HEALTH PROJECTS INTERNATIONAL
Suite 1, Ground Floor, 68 Alfred Street, Milsons Point, NSW,
2061
www.hpi.net.au healthpi@ozemail.com.au ACN 066 856 595
Tel: (02) 94604199 Fax: (02) 94604299 ABN 33 066 856 595

**Re: Macquarie University Private Hospital
Major Project Application MP 06-0172**

Attachment A

Attachment B

b) Height cont

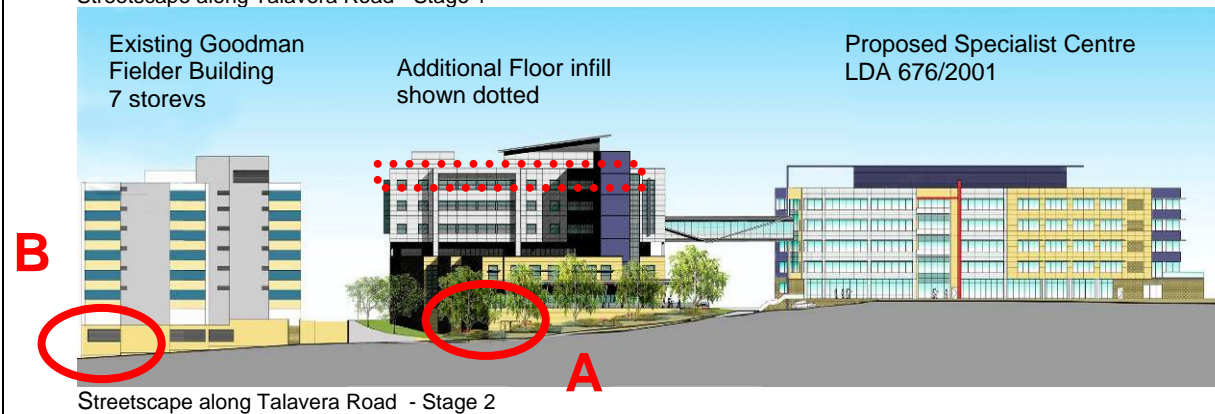
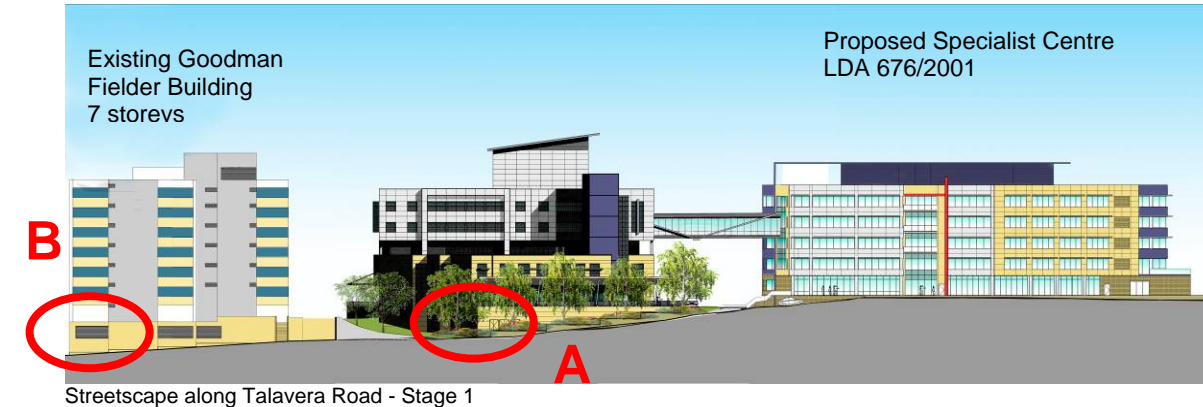
<p>b) Height</p> <p>The Department understands that there is currently a six storey height limit applicable to the site. Section 6.1 of the environmental assessment seems to suggest that Stage 1 will comprise 5 storeys, whilst Stage 2 may include an additional storey.</p> <p>Page 61 indicates the proposal exceeds the height controls; however it is unclear whether this non-compliance relates to Stage 1 or Stage 2 and as such clarification is requested. Justification for any height departure should be provided as well as documentation that demonstrates there are no suitable complying alternatives.</p>	<p>As shown in the response to item a) we believe that the extent of the building in terms of staging is unambiguous, and is comprehensively described in the EAR and supporting documentation.</p> <p>The department apparently seeks justification for the departure from the height limit of six storeys on this area of the Macquarie University precinct as defined in Ryde Council Draft DCP 55. This issue is discussed at some length in the current Project Application – refer to Sections 8.3.5 Streetscape (page 64) and 8.3.7 Maximum Height Control. (EAR pages 68 & 69)</p> <p>Briefly, due to the topography of the site, which falls sharply along Talavera Road (5 metres in level along the eastern boundary), the proposed building will protrude more than 1200mm above the natural ground level, for a small portion along Talavera Road by a length of approximately 4000mm at the south eastern corner and 5000mm along the south western boundary with Goodman Fielder, effectively making the building 7 storey's high. The extent is highlighted in A below. This will occur upon completion of Stage 1 of the project, as the lift and plant rooms are being constructed to the height required to serve the project at its ultimate potential (i.e. at the completion of Stage 2).</p>

It should be noted that the Goodman Fielder building adjacent is effectively 8 storey's high at the south eastern corner, being ground floor plus 6 levels above and the basement protruding more than 1200mm in the bottom left hand corner, as demonstrated in **B** below.

Ryde Council does not share the Department's concerns about minor departure form the height controls, and notes that the issue had been discussed during pre-lodgment meetings.

(c) Visual Impact Analysis cont

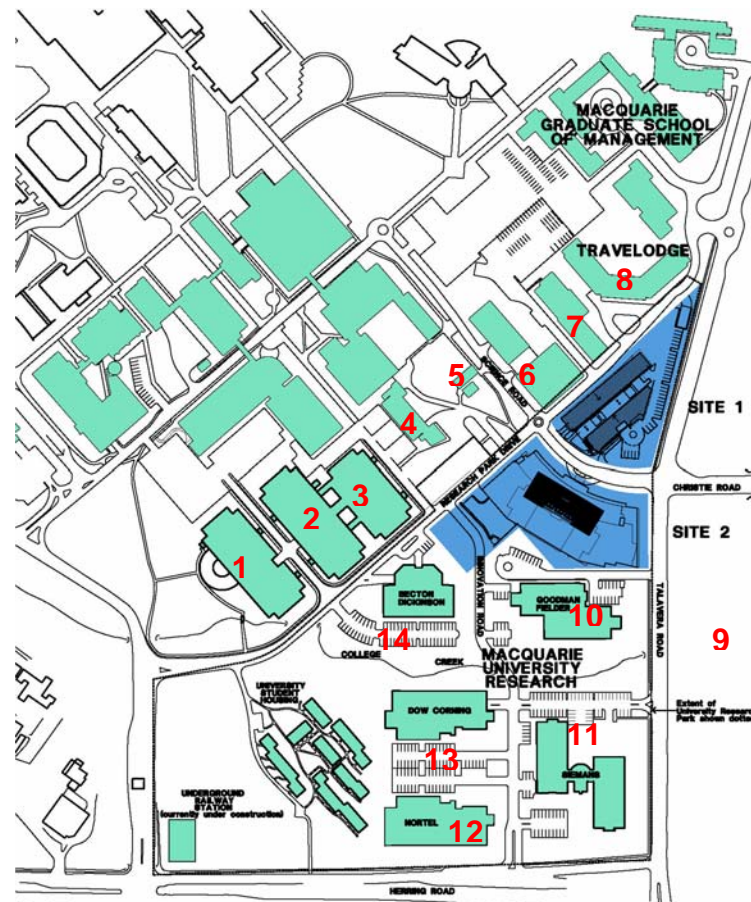
<p>(c) Visual Impact Analysis</p> <p>The Department requests a plan be produced to show existing reduced levels (RLs) (AHD) for topography and ground levels, future ground level RLs and maximum future RLs of proposed development envelopes, and number of storeys (including floor to ceiling heights) for the entire development (i.e.: Stages 1 and 2).</p> <p>All additional plans should be produced at an appropriate scale (A1 size or similar) and encompass the surrounding area in order to show the context of the site in the immediate locality. The plans will ensure that the Department can carry out an accurate assessment of the proposal.</p>	<p>The department has requested additional information pertaining to the context of the building. This information is comprehensively addressed within the current Project Application. If these are not adequate in the Department's opinion, we would request that specific issues are identified.</p> <p>Once again we confirm that that the application refers to a staged construction of the <u>entire</u> Hospital, with Stage 1 being undertaken in the first instance and Stage 2 at some later date, yet to be defined.</p> <p>We refer to the following sections and the information contained within -</p> <p><u>Volume 1</u></p>

Also note that Figure 16 on (EAR page 32) details the surrounding built form, and the height (in storeys) of adjacent buildings.
